10th Annual Concrete Conference

Concrete Specification and Roadway Standard Revisions

January 27, 2009

RC-24M Pavement Relief Joint Pub. 72 Change 2

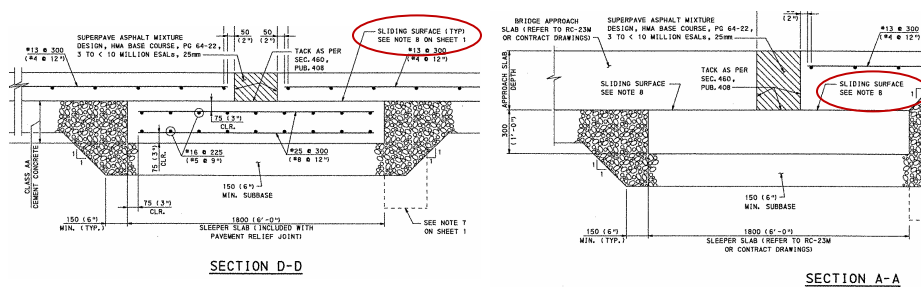
- 504.2 Material -- 3rd, 4th & 8th Bullets
 - Eliminated Bituminous Paper and Wearing Course references and added Polyethylene Sheeting to coincide with RC-24M revisions
- 504.3(b) Subslab
 - Revised subsection name to Sleeper Slab

- 504.3(c) Base Course
 - Moved this subsection to 504.3(d) and deleted the Wearing Course Subsection 504.3(d)
 - Renamed Subsection 504.3(c) to Polyethylene Sheeting
 - To be constructed in accordance with Section 505.3

8. TROWEL SMOOTH AND PLACE 2 LAYERS OF 0.1 mm (4 MIL.) POLYETHYLENE SHEETING AS BOND BREAKER.

RC-23M Bridge Approach Slabs Pub. 72 Change 2

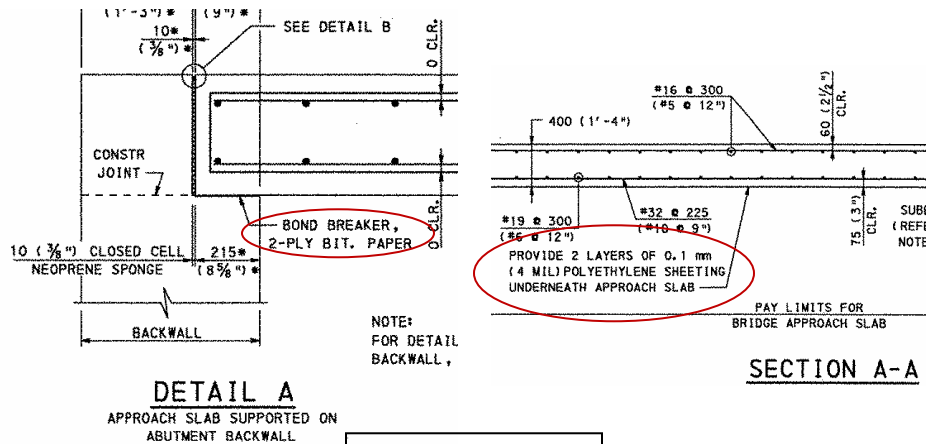
- 505.1 Description
 - Revised subsection to state work includes "associated sleeper slabs, including the subbase material and necessary excavation"
 - Further revised subsection to state: "Two layers of 0.10 mm (4.0 mil) polyethylene sheeting to be used as a bond breaker under the bridge approach slabs"

- 505.3 Construction
 - Eliminated all reference to Section 1026.3 and longitudinal joint requirement
 - Added the following subsections:
 - (a) Excavation
 - (b) Polyethylene Sheeting

- 505.4 Measurement and Payment
 - Revised subsection (a) to include excavation, subbase material, polyethylene sheeting, bituminous paper, cement concrete and reinforcement bars
 - Eliminated subsection (b) Neoprene Strip Seal Dam in its entirety

RC-25M Shoulders Pub. 72 Change 2

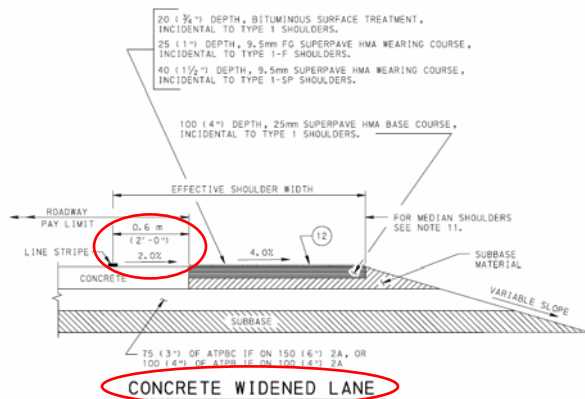
- RC-25M Shoulders
- RC-27M Plain Concrete Pavement
 - Added details to increase the standard lane width from 12' to 14' for concrete pavements when constructing bituminous shoulders
 - Moves the bituminous shoulder joint 2' away from the Travel Lane

- RC-25M, Sheet 1 (8/29/2008)
- Other minor changes to Sheets 2, 3, and 4

RC-27M Plain Concrete Pavement Pub. 72 Change 2

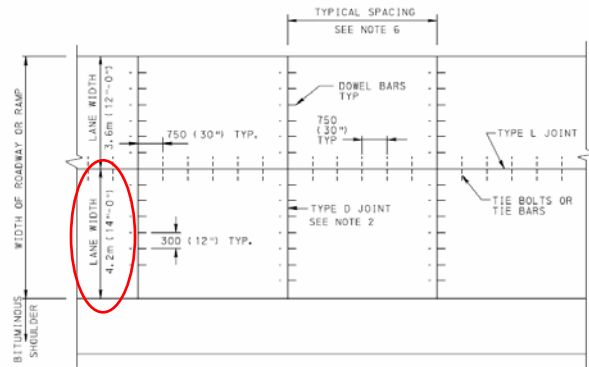
• RC-27M, Sheet 2
(8/29/2008)
